Change Order 2

The Restore Louisiana Homeowner Assistance Program

Insured: Steven Thibodeaux
Home: 8716 Fulton St
Metairie, LA 70003

Estimate: 251908_CO_2

- 3 Main level/CO-1 Exterior - 104-
Exterior
Date Taken: 5/1/2024
Taken By: Lemoine

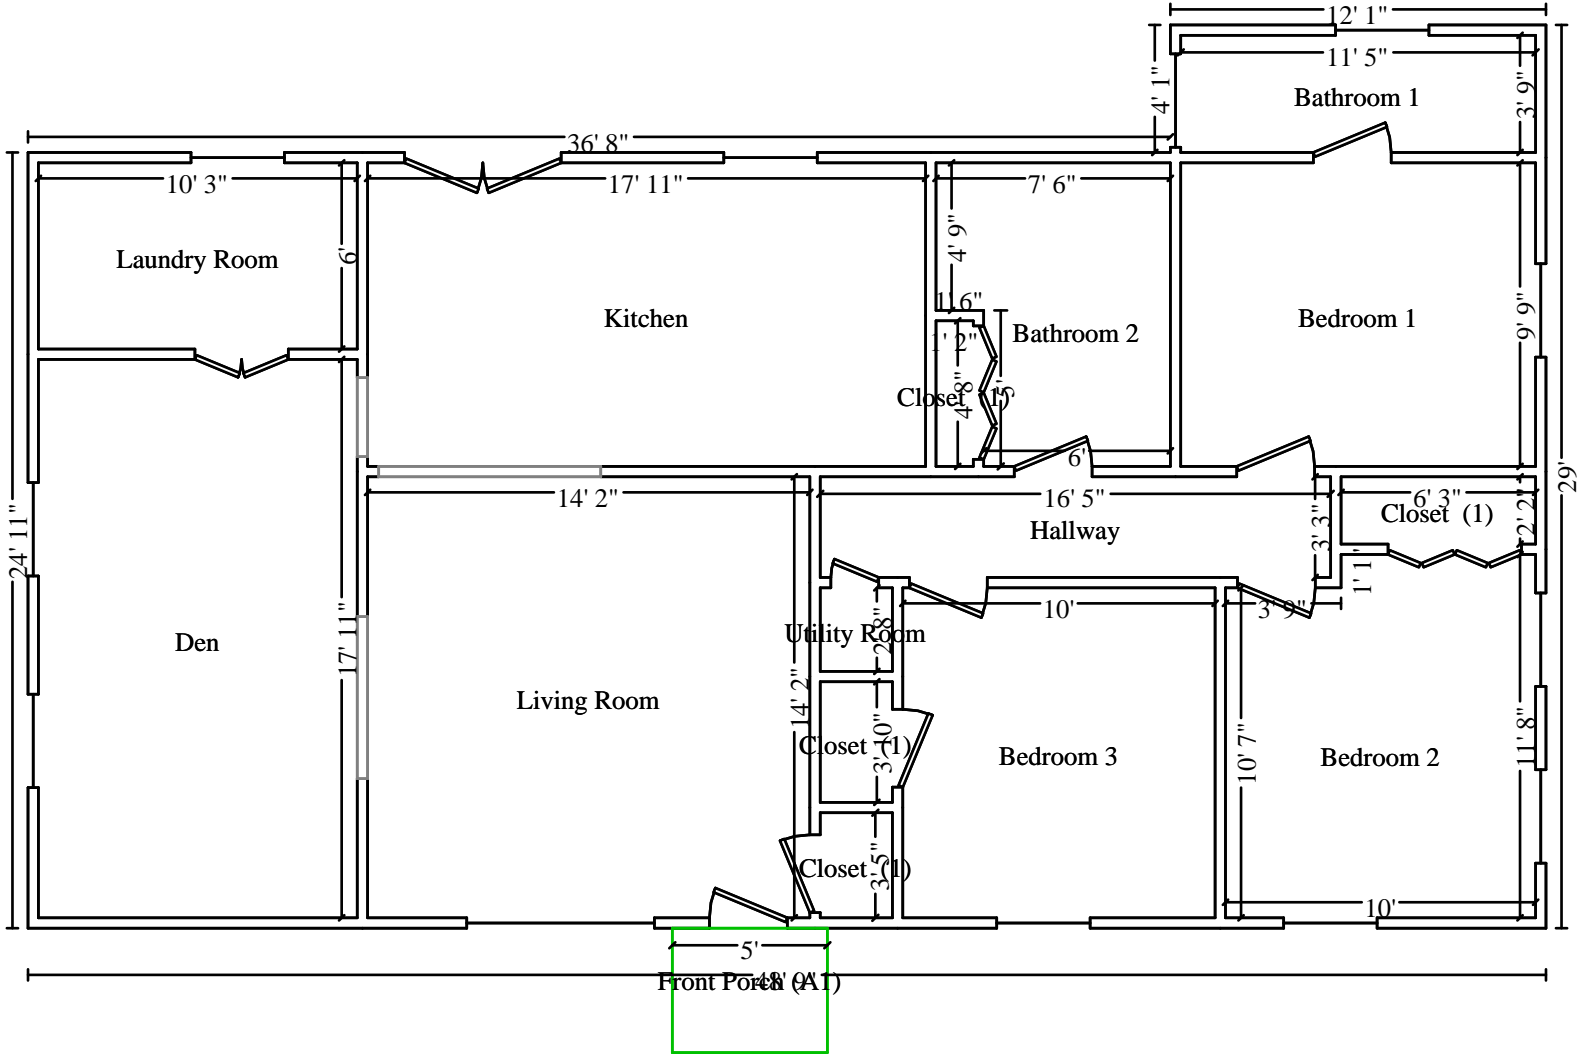
Gutter loose to be stabilized with new
hangers
